the **arbor centre** CONSULTANCY

Revision 1 - Stage 2 – Collaborative Design Review
Australian Hockey Stadium - Curtin University
July 2024

ASPECT Studios

Reference Number: Q006842/1

Figure 3. 2310-DA-1101-Site Plan (I) – Supplied by Aspect Studios – July 2024

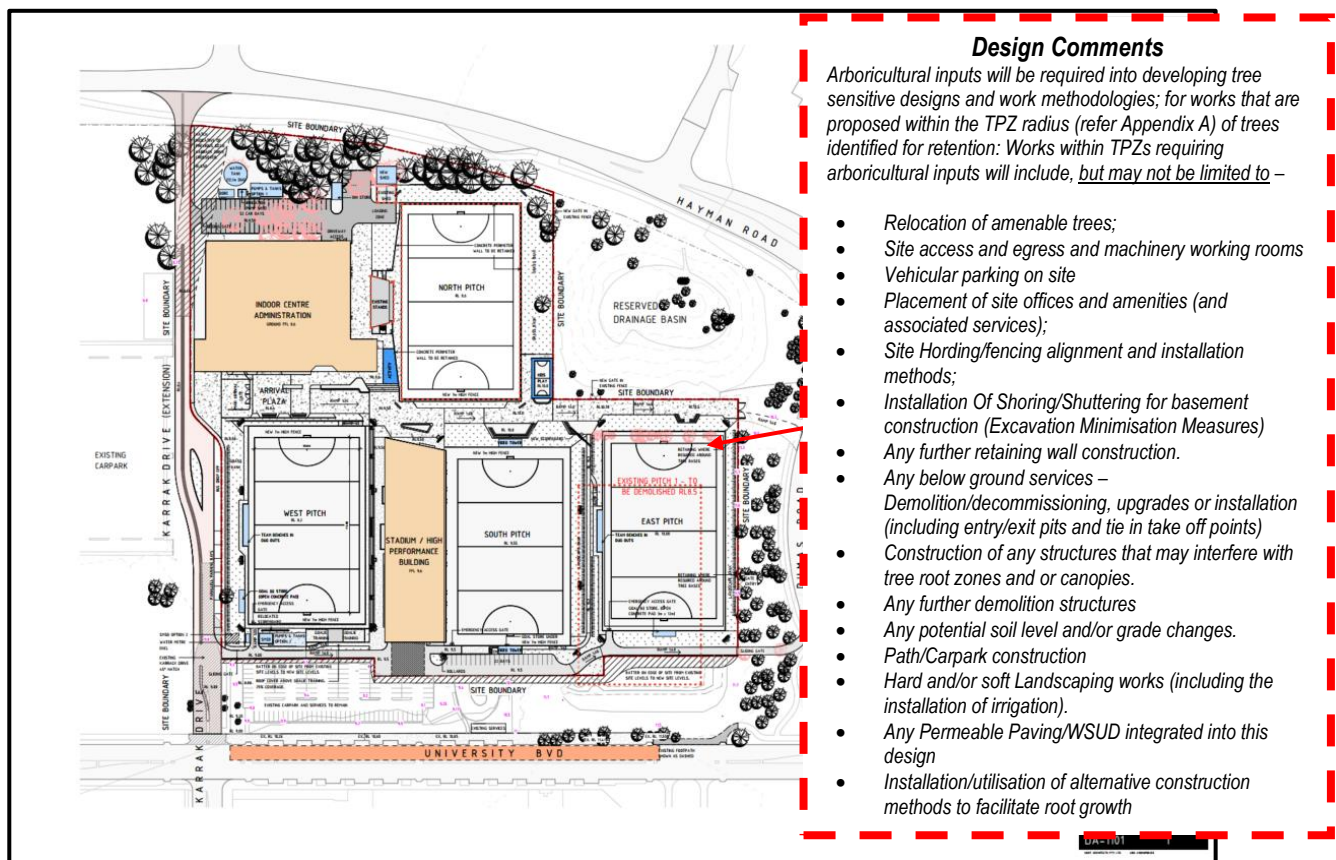
This current proposal will require collaboration between Arbor Centre, Aspect Studios and the design team, to review and in some instances modify the proposal in order to successfully retain the subject trees. Where encroachment (demolition, construction, excavation, landscaping or otherwise) into the nominal AS 4970 Tree Protection Zones is required (refer Table of Results for specific TPZ measurements & Appendix A for detail), further Arboricultural input will be necessary to assess the extent of potential impact that may occur and if required, provide Arboricultural measures that can be taken to enable modification of the nominal TPZ and allow root zone encroachment to occur (as identified below).

Validation of the sites survey data should be undertaken to ground truth location of trees in relation to the proposed structures and works. This will ensure that any issues regarding alignments in conflict with existing trees are addressed in the design stages for the project.

To enable greater retention of tree root mass and lessen root zone encroachment, consideration should be given to relocating/diverting any construction works beyond the TPZ projections – refer *Appendix A AS 4970* for detail. Where diversion of works/impacts to beyond the TPZ is not possible/practicable, site assessment and exploratory excavations may need to be undertaken by Arbor Centre to quantify potential root loss, identify measures that may limit (additional) unnecessary root damage/impact; and/or provide possible remedial measures that effectively offset potential root loss. Furthermore, exploratory excavations can provide a better understanding of actual depths of roots and if descending/oblique (anchorage) roots are present (or otherwise) as part of confirming site safety and identifying actual tree risk mitigation management options.

Where scheduled works cannot reasonably be diverted outside the TPZ, Arboricultural supervision will be required to quantify potential root loss, limit unnecessary root damage/impact, and/or provide possible remedial measures necessary to offset potential root loss. Works include but are not limited to;
